TO: DEVELOPMENT REVIEW BOARD **DATE:** November 7, 2002
FROM: CURRENT PLANNING SERVICES
SUBJECT: CASE 53-DR-2002
REQUEST: Approve Exterior & landscaping modifications
PROJECT NAME: Rush Bar/Lounge
LOCATION: 4426 N Saddlebag Tr

REQUEST: The request is for the approval of a new site/landscape plan and elevations for an exterior façade renovation on the existing office building located on Saddlebag Trail. The applicant plans on opening a bar/lounge in the building.

STIPULATIONS for 53-DR-2002

SOUTH ELEVATION
DRB CASE # 220-PA-2002
RUSH SCOTTSDALE

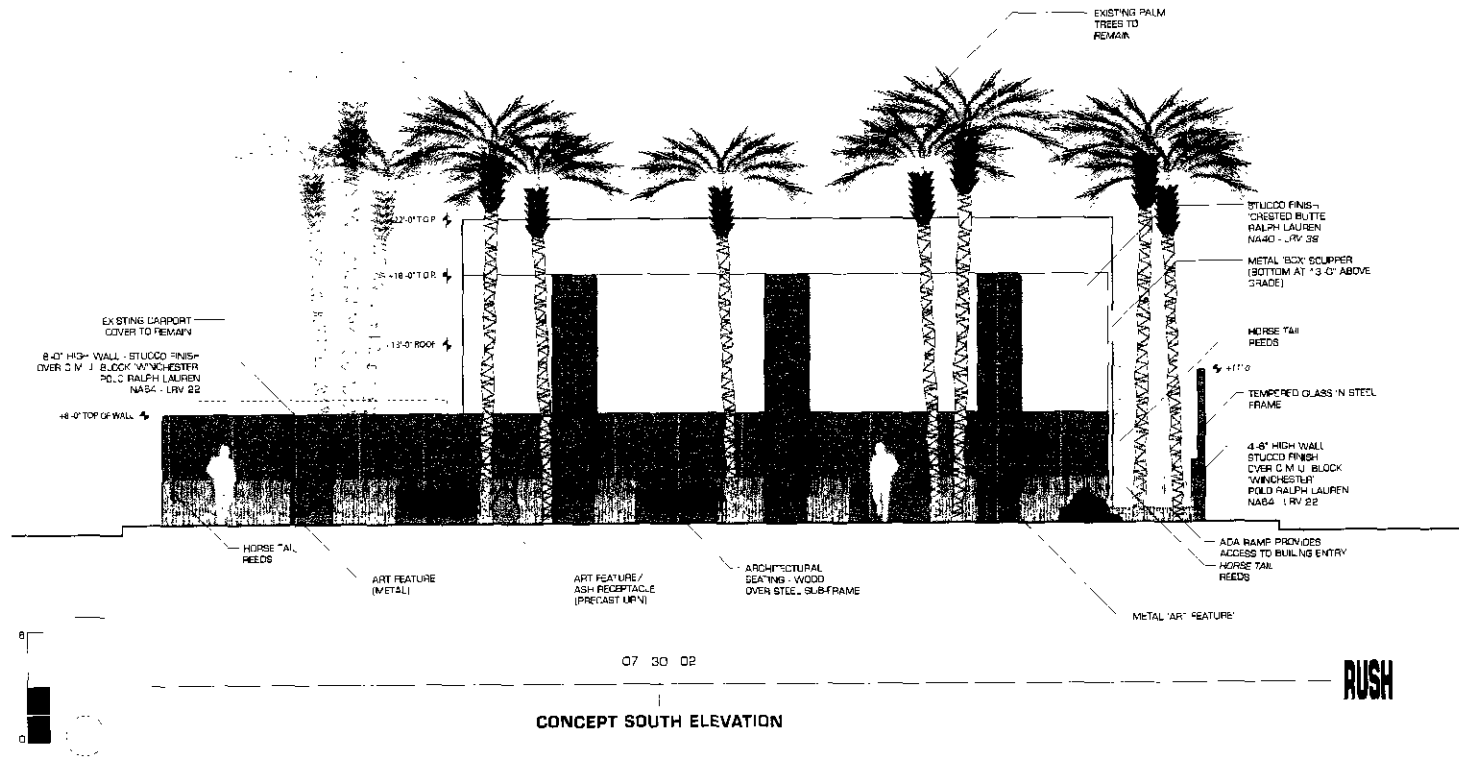
The applicant proposes to renovate the front of the building by breaking up the wall plane and raising the middle section of the façade to 22 ft. and add 3 ft. to the side parapet walls which helps hide mechanical equipment. A new recessed front door and a metal canopy over the front entrance will also be added. The wall plane of the south elevation will be broken up with three vertical metal features, the addition of cantilevered seating benches, and the extension of the 8 ft. high screen wall along the

façade (attached to existing wall). All walls will be resurfaced with smooth stucco painted a light khaki accented with a dark khaki.
